Farley Exam Review comments FA2015-301

Farley Nuclear Plant ILT 38 Exam Question 92

NMP-AD-003

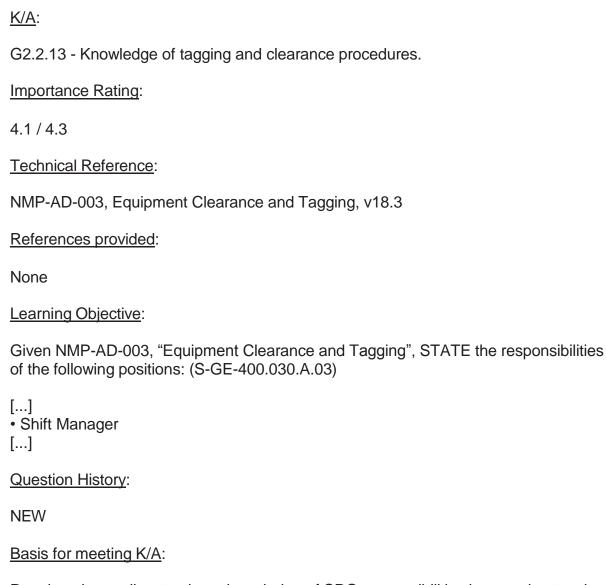
Students stated that there is no correct answer since all conditions for signing off the Work Document Holder are not met. No one can sign off the Work Document Holder based on the conditions in the stem.

During post exam feedback, some students stated that based on the question asked, there is no correct answer. Since all the requirements of NMP-AD-003 were not met, no one could sign off the Work Document Holder. NMP-AD-003 has 3 requirements for the Shift Manager to be able to sign off the Work Document Holder, and only 2 of the requirements were listed in the stem. It was not stated in the stem that "A knowledgeable individual (department supervisor) has conducted a check of the job and determined the release will not be detrimental to the plant or personnel." This "knowledgeable individual" would normally be someone from the maintenance department who had in depth knowledge of the work in progress that required the tagout. The Maintenance Director answer choice was chosen once, and the Maintenance Manager was chosen once.

Although the intent of the question was to ask "which individual has the authority to sign off a Work Document Holder from a tagout when he is offsite and unavailable", the question is asking "which one of the following can sign off the Work Document Holder". For the conditions given, no one can sign off the Work Document Holder since all the requirements are not met.

The third requirement of NMP-AD-003 was not stated in the stem and could not be assumed to be met, therefore no correct answer exists.

The Facility agrees. The question appears faulted based on the student feedback. See the attached request for an Exam Key Change.

Request an Exam Key Change to remove Question 92 from the exam due to no correct answer available.
